HFC-6000 Safety System

Accepted Safety Evaluation plus Topical Report

(Including Request for Additional Information and Responses)

**SUBJECT: FINAL SAFETY EVALUATION FOR DOOSAN HF CONTROLS CORPORATION
HFC-6000 SAFETY SYSTEM TOPICAL REPORT (TAC NO. MD8462)**

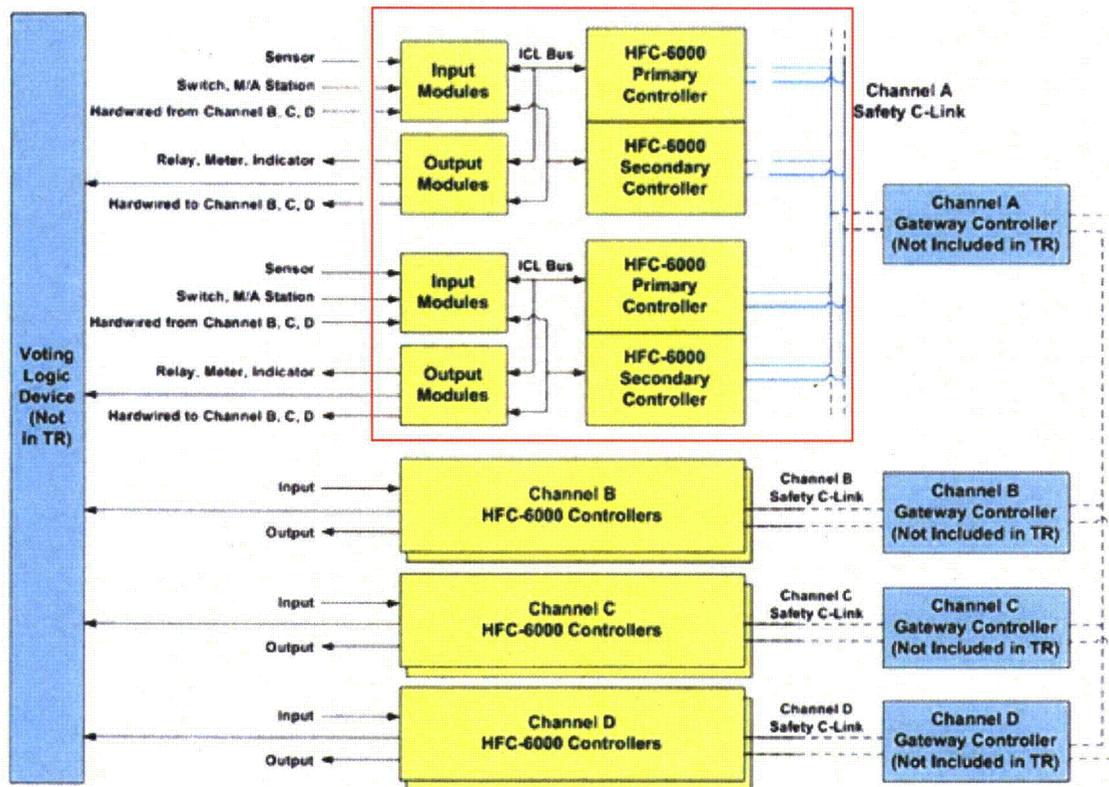
No.	Draft SE Location	Suggested Change	NRC Resolution	NRC Disposition
1	Page 6, Figure 1	The red dashed-line box should extend to cover the other node and the safety C-Link in the figure.	Accepted	Changed per comment. The Figure caption now reads: "Safety System Architecture Example Based on HFC-6000 Platform [Note: Only the components contained within the dashed-line box are within the scope of the topical report evaluation. Intra-channel communications are included in the scope of this evaluation; however, inter-channel communications have not been reviewed, nor approved.]"
2	Page 6, Line 21	Remove "one node of"	Accepted	Editorial
3	Page 7, Lines 13-19	Remove "While the network interface for the HFC-6000 controller is an integral platform nodes, the fiber optic network medium, including the fiber optic transmitters that provide electrical-to-optical coupling, are not within the scope of the platform. Also,". Line 16, make "the gateway" become "The gateway." Lines 18-19, remove "or other systems, either safety-related or nonsafety-related,"	Not accepted	However, for clarity change lines 15/16 to read, ". . . not within the scope of <u>this review.</u> " Also, change line 17 to read, "...not within the scope of the platform <u>for purposes of this review.</u> "

No.	Location	Suggested Change	Type of Change	Justifications
1	p.6 Figure 1	The red dashed-line box should extend to cover the other node and the safety C-Link in the figure. See comments in the document.	Content	Safety C-Link communication is part of the review scope. See reference 1 of the draft SE and RAI #122 response.
2	p.6 line 21	Remove "one node of"	Content	Same justification as in comment no. 1
3	p.7 lines 13-19	Remove "While the network interface for the HFC-6000 controller is an integral platform nodes, the fiber optic network medium, including the fiber optic transmitters that provide electrical-to-optical coupling, are not within the scope of the platform. Also, ". Line 16, make "the gateway" become "The gateway". Lines 18-19, remove "or other systems, either safety-related or nonsafety-related,".	Content	Same reason as change no. 1. Plus HFC-ILR06 is part of the review scope. See table 1 of the draft SE.

The following figure replaces figure 1 of RR901-001-01, "Responses to RAI Part 3", Rev. A.

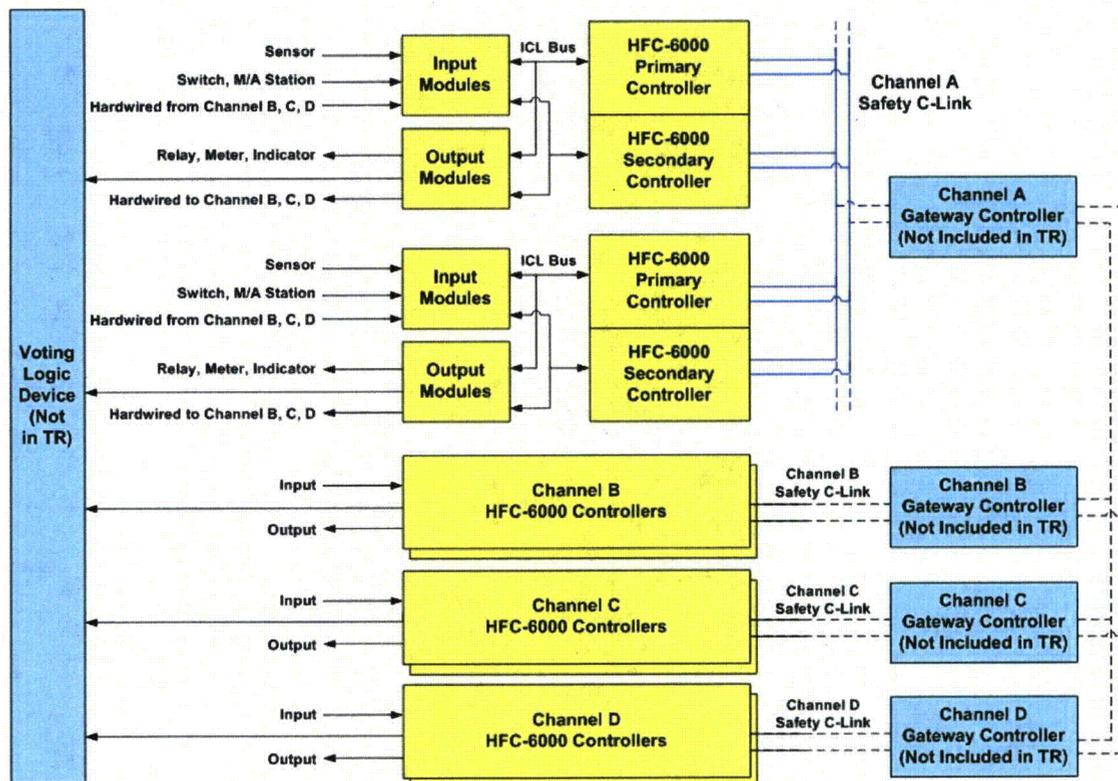
RAI 118 Response
